PROJECT :	BHADRADRI THERMAL POWER STATION 4 X 270 MW, UNITS-1 TO 4, MANUGURU, TELANGANA, INDIA			
EPC CONTRACTOR	BHARAT HEAVY ELECTRICALS LIMITED INDUSTRIAL SYSTEMS GROUP ISG-BANGALORE			
		NAME	SIGN	DATE
	DRN.	R.K		10.08.15
	CHD.	MNK		12.08.15
	APP.	RSP /VSD		12.08.15

TITLE : GA AND LOAD DATA OF BCN-6A/B		TOTAL SHEETS SHEET. NO.
SCALE	BH&L JOB NO. IS-1-14-2007	BH&L-ISO DRG.NO.:	IS-1-GA-691-101-M013

Project : BHADRADRI POWER 4x270MW TELANGANA
Client : TELANGANA STATE POWER GENERATION CORPORATION LTD.
Consultant : DESEIN PRIVATE LTD.
Contractor : BHARAT HEAVY ELECTRICALS LTD.

COMPLIANCE TO COMMENTS OF DESEIN			
ON GA DRAWINGS OF BCN6AB, R0 SUBMITTED BY BHEL FOR APPROVAL			
Ref:	Comments made on GA Drawing prints of BCN-6AB, R0 by DESEIN		
SL NO	DESEIN COMMENTS.	COMPLIANCE / CLARIFICATIONS BY BHEL	REMARKS
1	Drawing fonts shall be increased.....	Noted & revised.	
2	Coordinates shall be marked in the drawing	Noted & revised.	
3	Finished ground level (FGL) of coal handling area shall be indicated in the notes.	Noted & revised.	
4	All * marked data shall be confirmed and notes may be corrected accordingly.	Wherever possible revised at this stage. However, it shall be taken care before

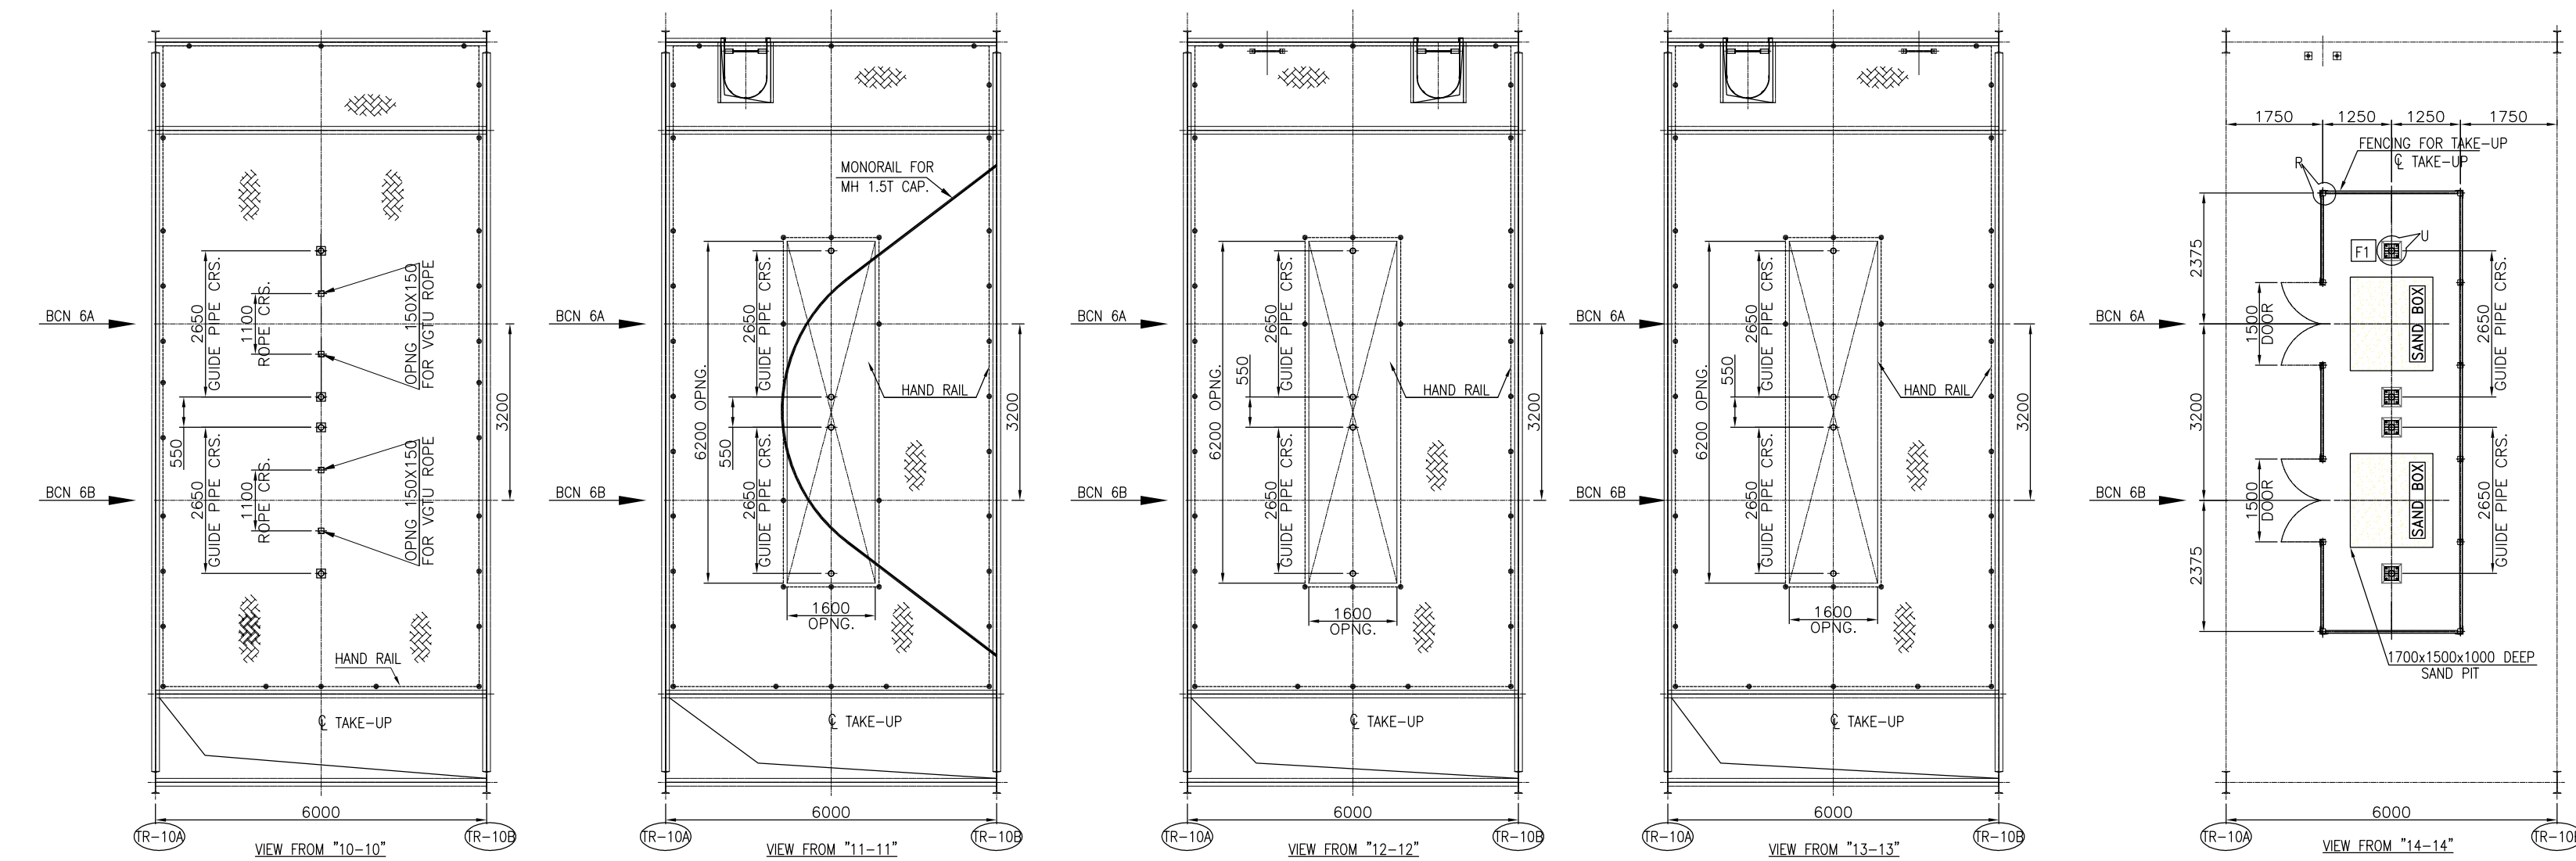
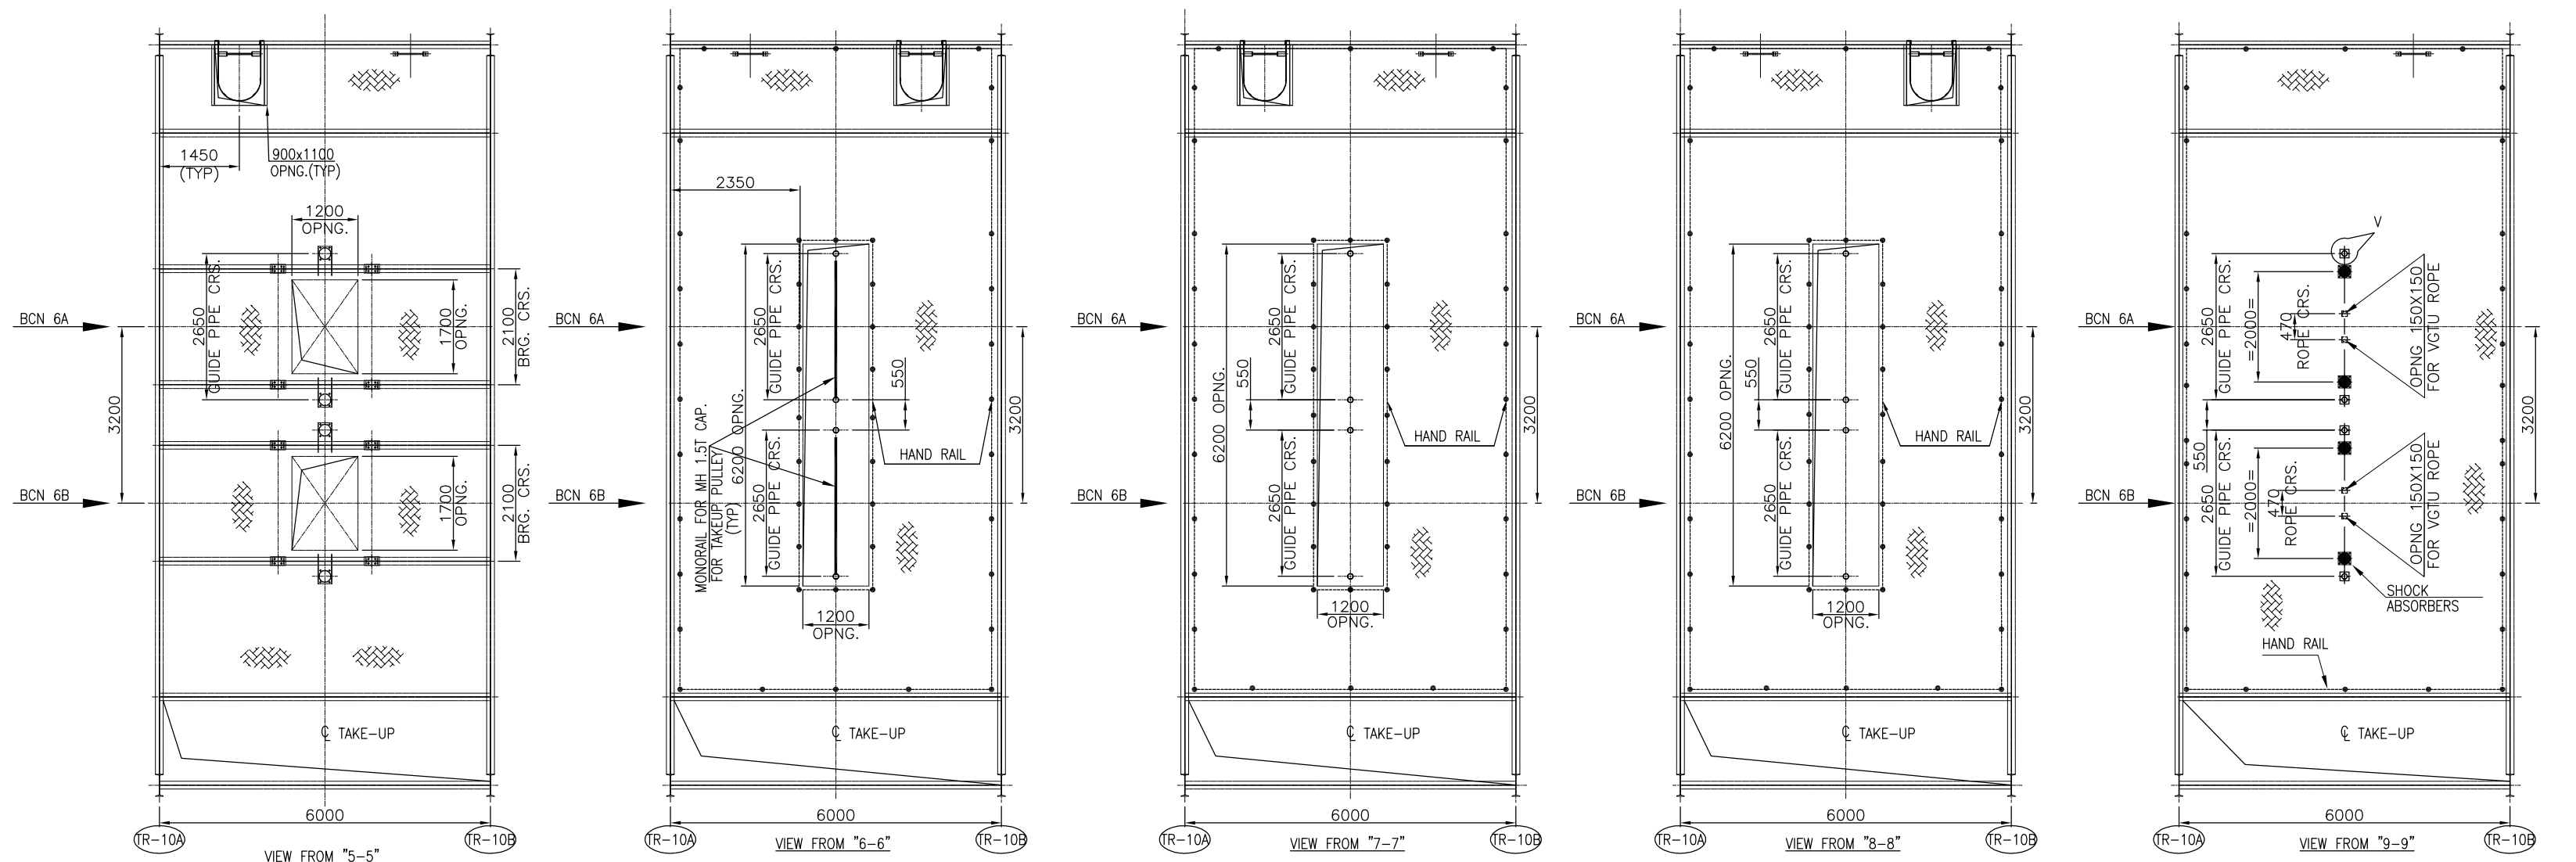
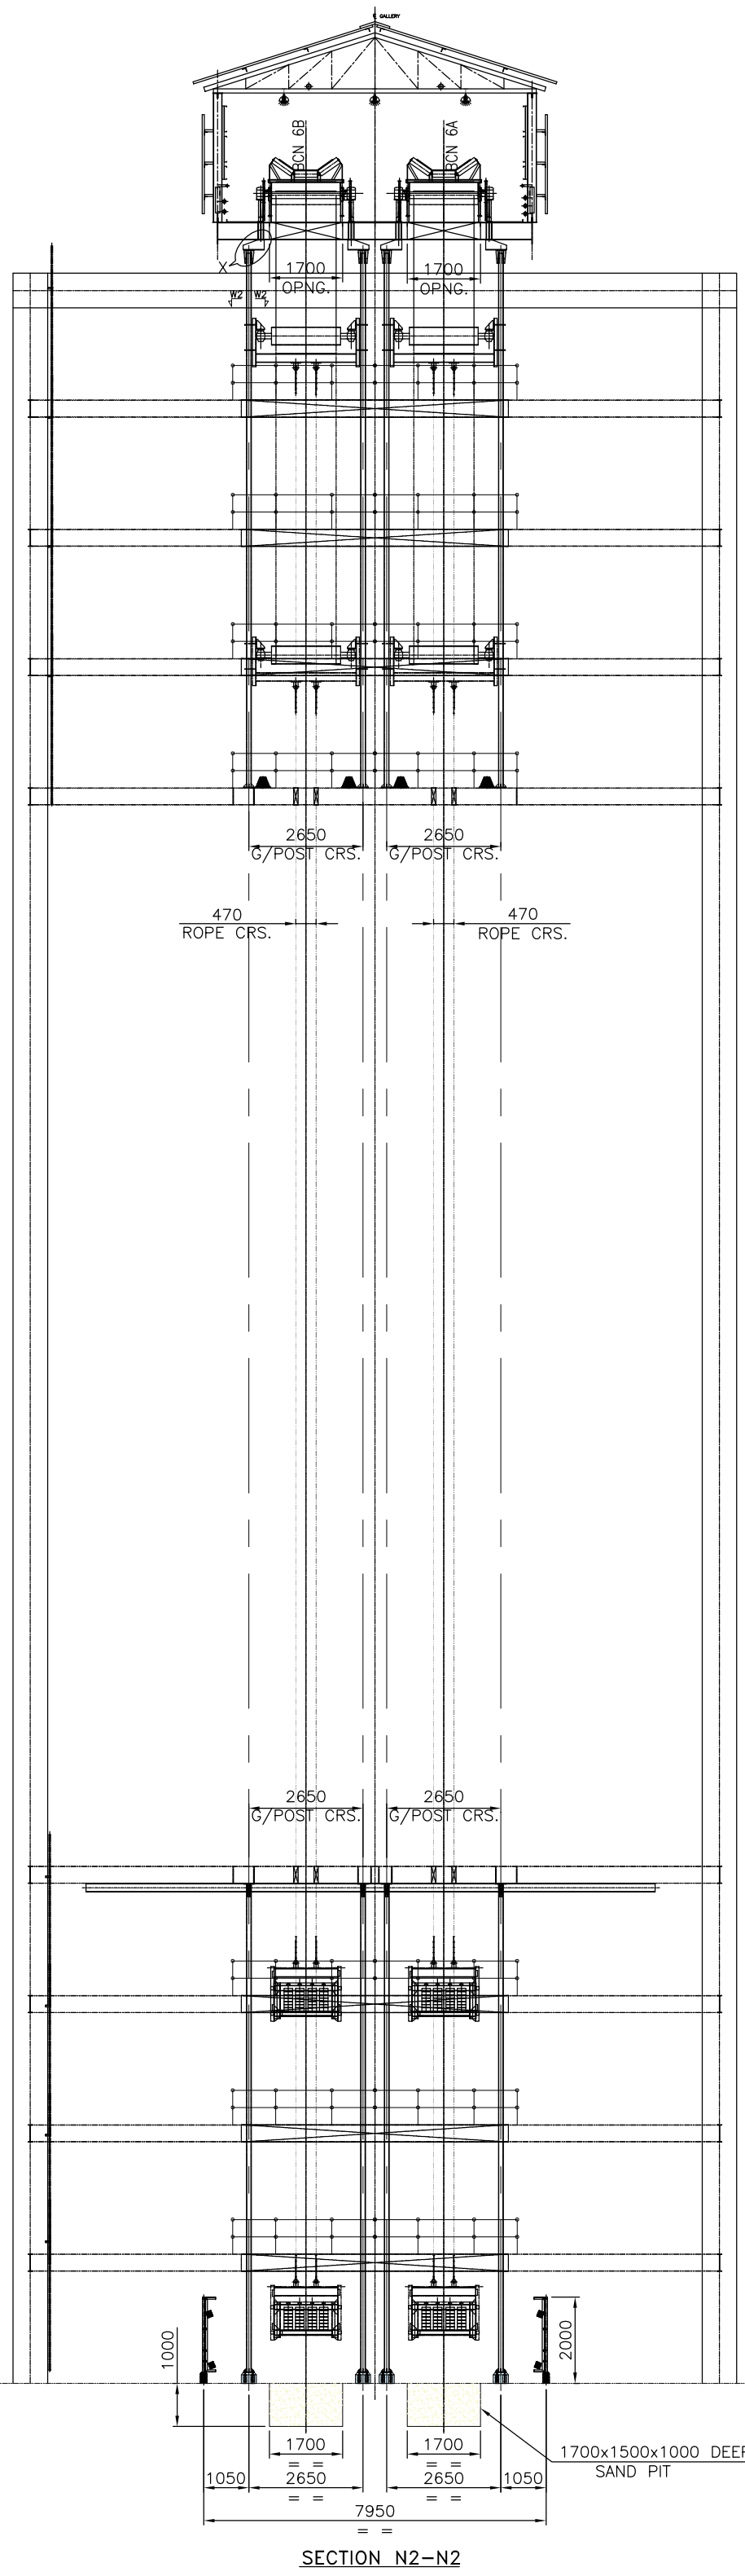
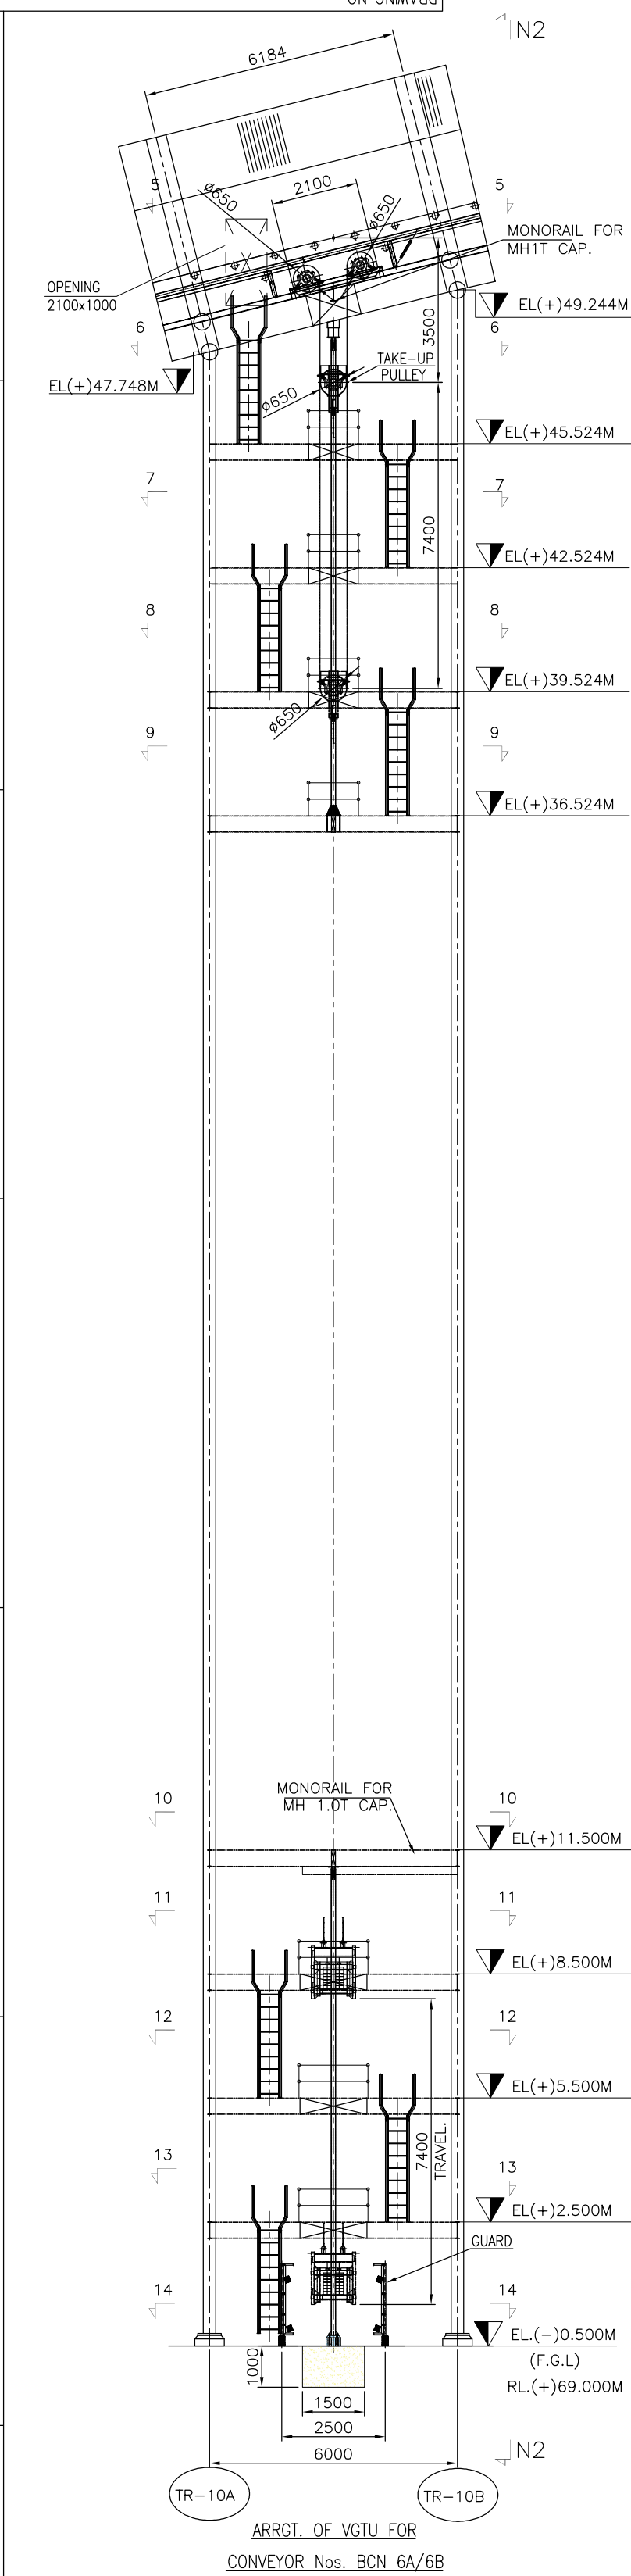
6	Refer Legend: All symbols shall be indicated	Noted & revised.	
7	Spacing of Self aligning carrying idlers shall be 5 m from either ends and 10 m throughout conveyor	Maintaining Self aligning carrying idlers at 5 m from either ends is not possible here, because it is coming in impact area at head end & in Transition idler area in tail end.	
8	Spacing of Self aligning return idlers shall be 10 m from either ends and 20 m throughout conveyors.	As per NIT, Self Aligning return idler will not be required for conveyors more than 400 m long where two roll return idlers are provided.	
9	Idlers below magnetic separators & metal detectors shall be of non-magnetic type.	Noted & revised.	
10	Maximum gap of transition idlers shall be 700mm	Noted & revised.	
11	Deflector roller, drive pulley & snub pulley shall be indicated in the drawing.	Noted & revised.	
12	Indicate brake details and provide coasting time calculations for the same.	Noted & revised. Coasting time calculations submitted already.

13	Pull cord switch shall be provided on both sides of conveyor.	Noted & revised.	
14	Belt sway switch shall be provided in pairs.	Noted & revised.	
15	Sand pit dimensions in plan and section are not matching.	Noted & revised.	
16	Zone location for various details shown shall be marked	Noted & revised.	
17	Take up pulleys, mesh guard, fall arrestor etc shall be indicated in Take up arrangement	Noted & revised.	
18	Each take up shall be provided with a marked cable by side of structure frame to monitor belt stretch	Marking shall be done on take-up structure frame.	
19	Skirt board and seal plate details shall be indicated in the drawing.	Noted & revised.	
20	External scrapper shall be multi blade sprung type	Noted & revised.	
21	Show horizontal and inclined distances between W.P, T .P & I.P	Noted & revised.	
22	Finished floor level (FFL) of mill area is 0 M instead of (-) 0.2M as per 0-00-620-87042 rev 2 (GA of Bowl mill). Please correct BCN 7 accordingly.	Noted & revised.

23	FGL & FFL of TP-5, BCN-6A/B shall be corrected as per plot plan.	Noted & revised.	
24	Submit General arrangement drawings of track hopper and stacker cum reclaimers for finalization of BCN-1A/B, 8 & 9.	GA of S/R & Track hopper submitted to TSGENCO / DESEIN already.	
25	TSGENCO requested & insisted to BHEL ISG, to consider Addressable type Belt sway and Pull cord switches only. BHEL will revert.	The Pull Cord & Belt Sway Switches of all the conveyors except Belt Feeder shall be addressable type
